IN THE DRAWINGS:

Remarks

ANNOTATED SHEET

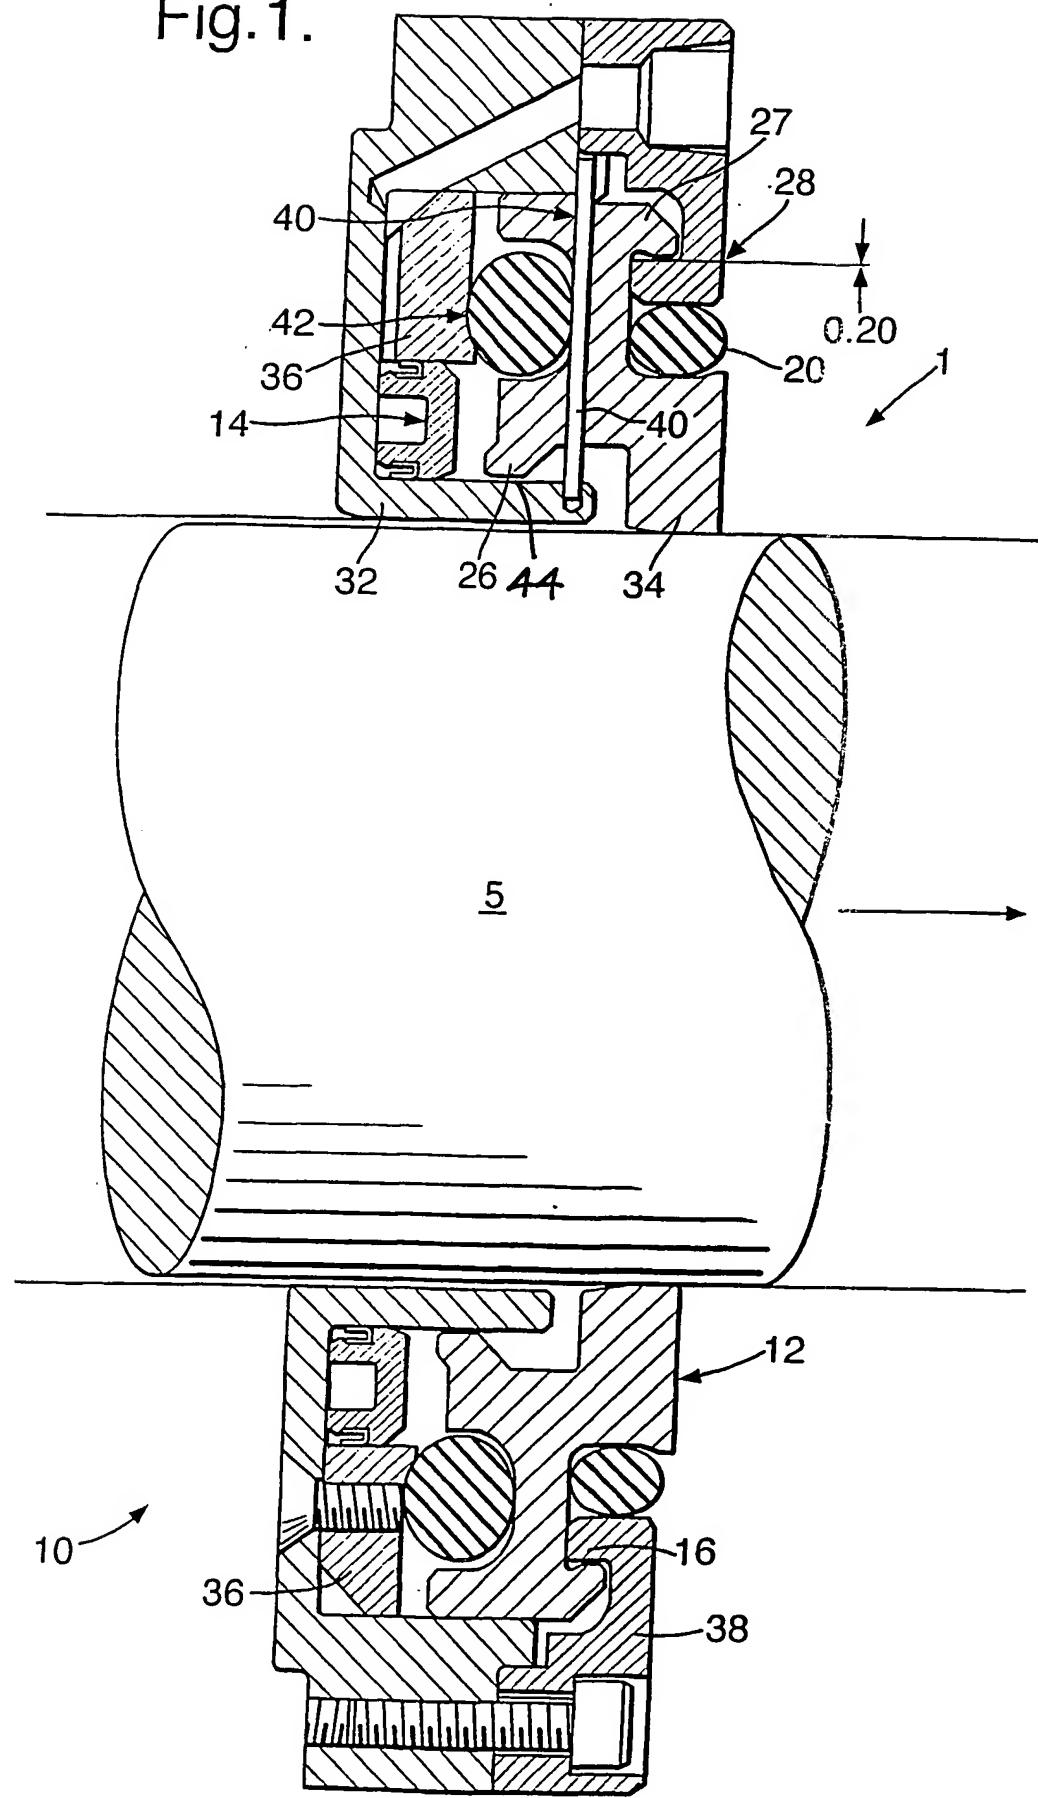
Turning first to the various objections presented by the Examiner with respect to the drawings beginning at page 2, paragraph 1, the "contact point 58" has been designated by the latter reference numeral in Figure 3. Accordingly, this objection has been rendered moot.

The objection with respect to reference numerals 56 and 57 has also been rendered moot by deleting each from Figure 3 of the drawings.

The final objection concerns the arrow from reference numeral 44 (Office Action, page 3, paragraph 3). The lead line from reference numeral 44 now correctly identifies the "gap" intended.

Two new sheets of drawings are submitted as "Drawing Replacement Sheets" of Figures 1 and 3 along with the corrected "Annotated Sheet Showing Drawing Changes." The Annotated Sheets reflect the addition of reference numbers 44 and 58 to Figures 1 and 3, respectively, and the elimination from Figure 3 of reference numerals 56 and 57.
